SUBJECT: Executive Committee Request

Watershed Science and Engineering Evaluation

To: Jim Kramer
From: Larry Karpack & Mark Indrebo, Watershed Science & Engineering
Date: July 7, 2015
Re: Wishkah Road and Mill Creek Dam projects

Figure 1 - Flood-prone areas of Wishkah Road

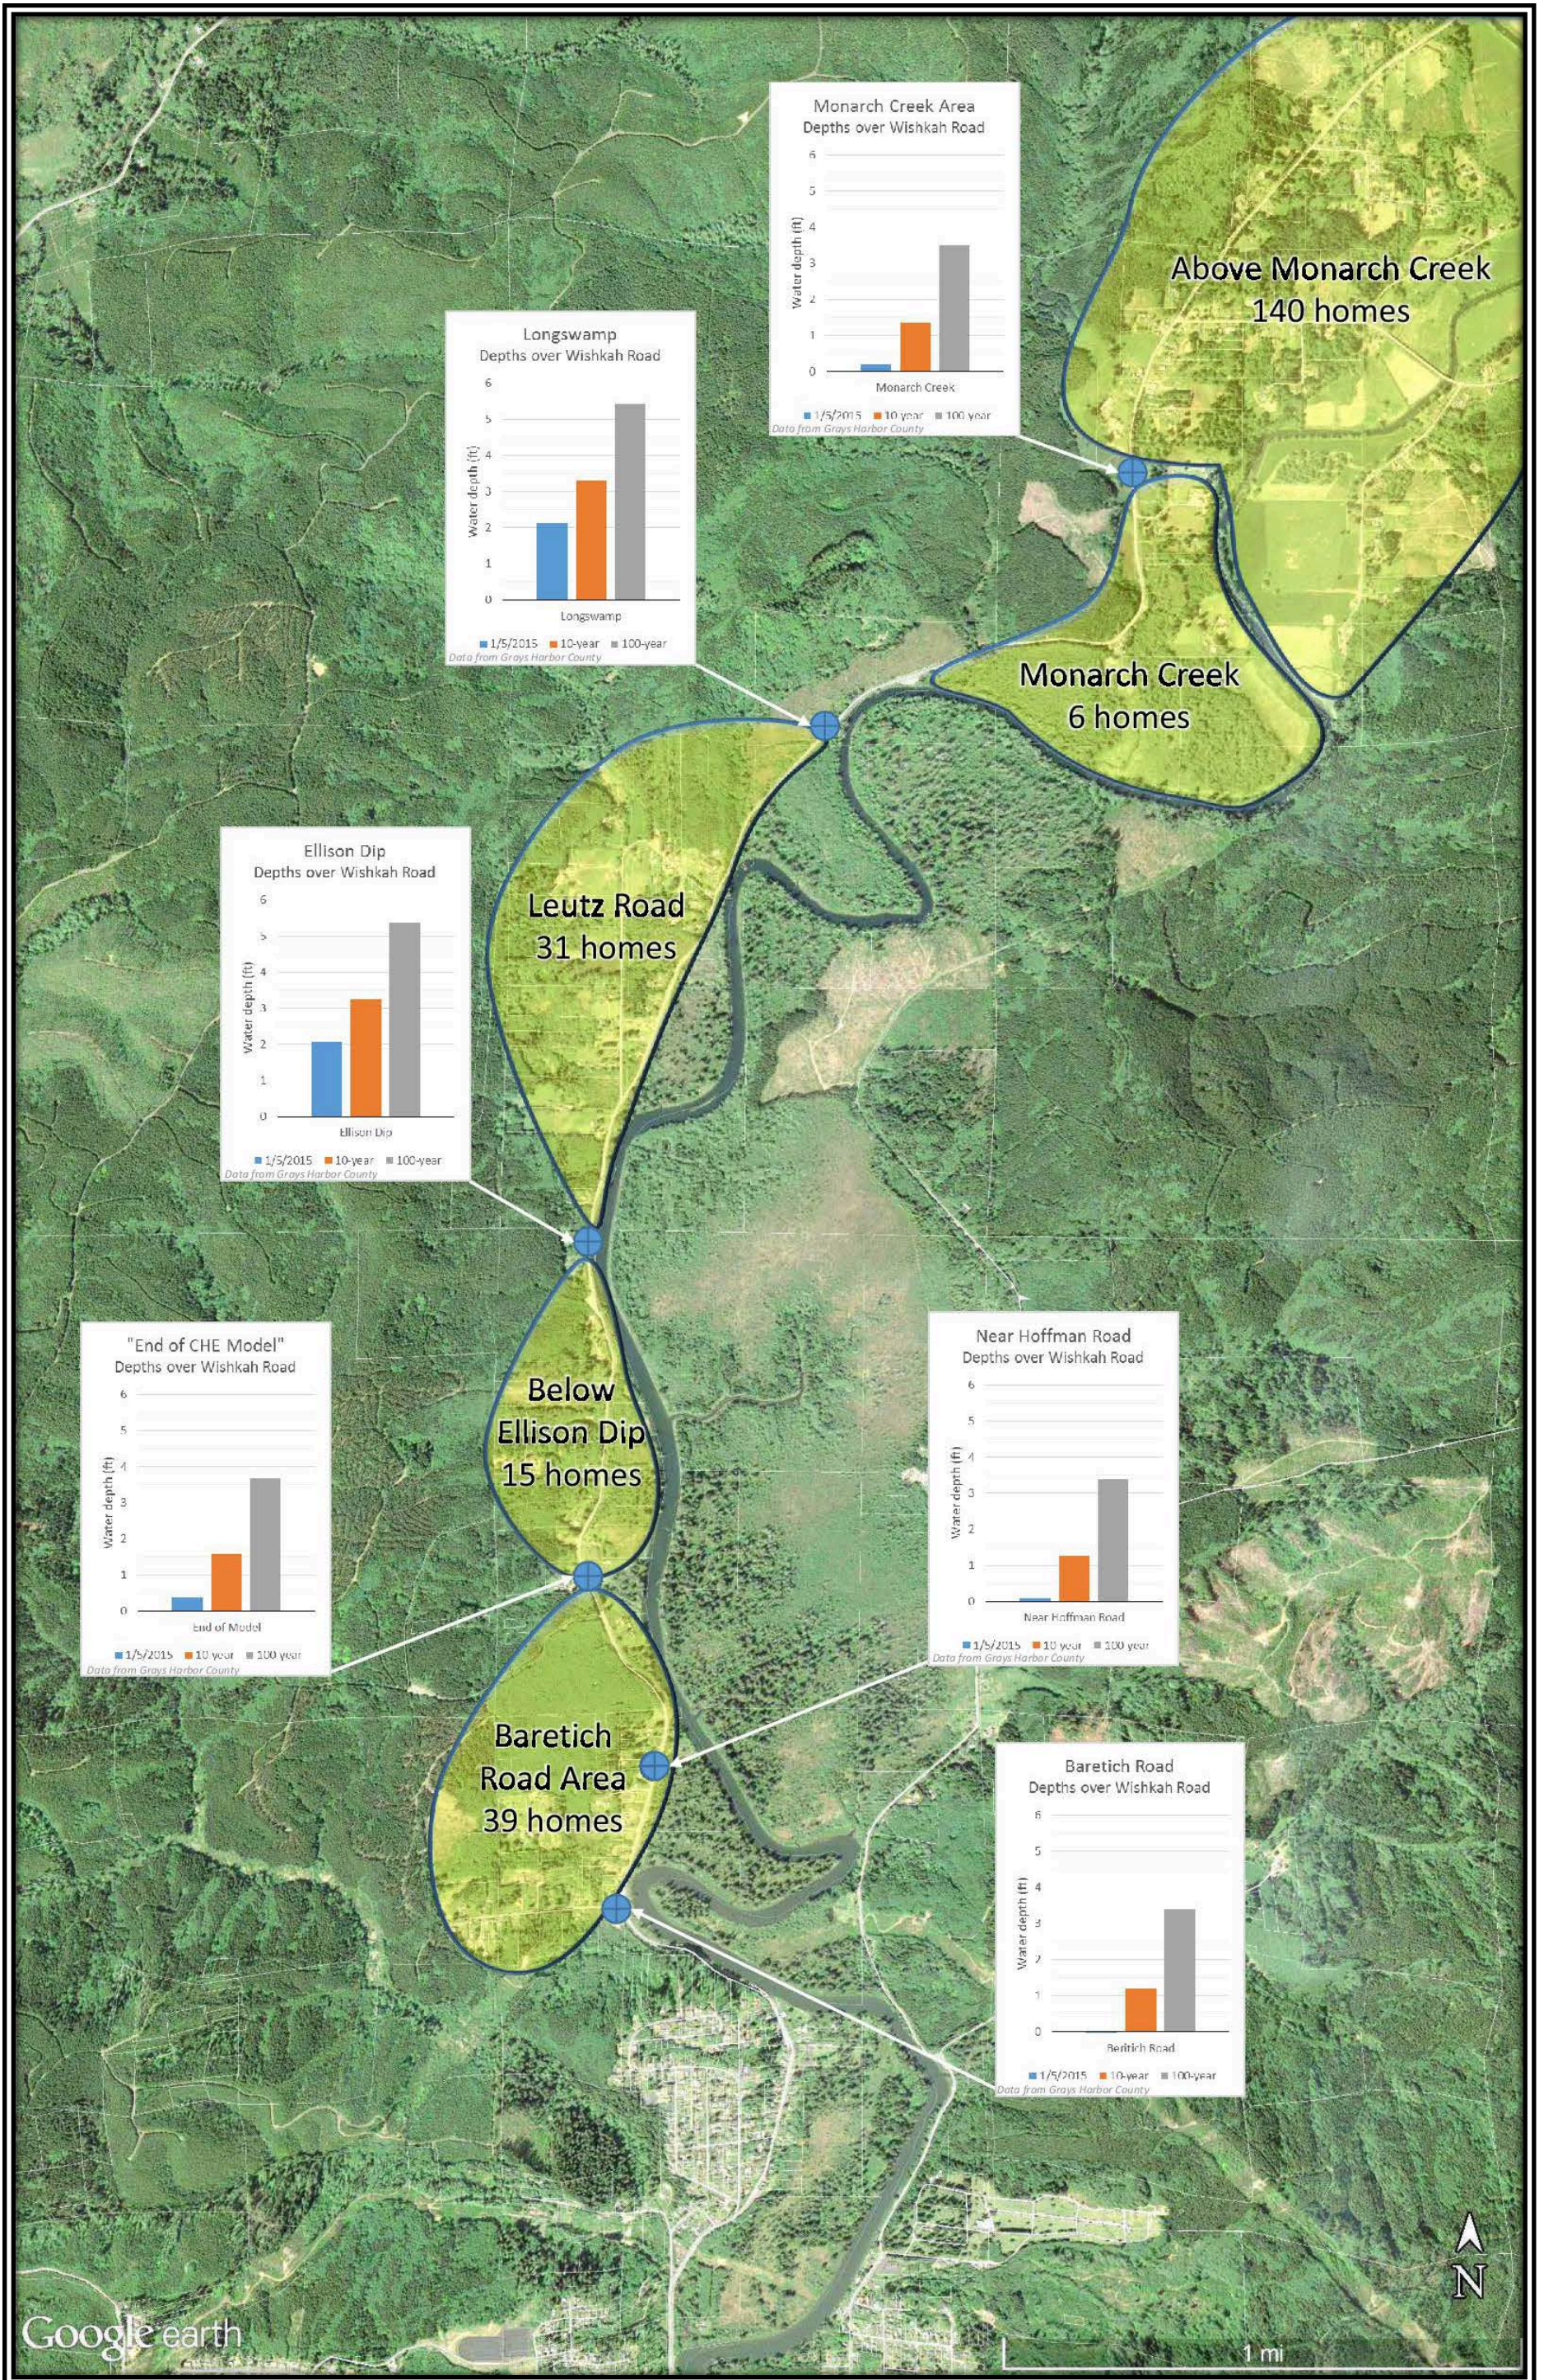
4. The analysis should be expanded to include a comprehensive evaluation of all of the low spots on Wishkah Road (Figure 1), and should include a way to prioritize road improvements to maximize benefits and optimize expenditures. It is apparent that more frequent and more severe flooding of Wishkah Road occurs at several upstream locations; fixing those problems may provide significantly greater benefit to homeowners who are isolated from emergency services during more frequent flood events (Figures 2, 3). In any case the benefits of simply improving the section of Wishkah Road near Baretich Road cannot be presumed to provide access to upstream residences unless other low lying sections of the road are also improved. A benefit-cost analysis that characterizes current impacts and evaluates and prioritizes improvements along the entire stretch of Wishkah Road from Baretich Road to the Wishkah Bridge would facilitate a comprehensive solution for improving emergency vehicle access.
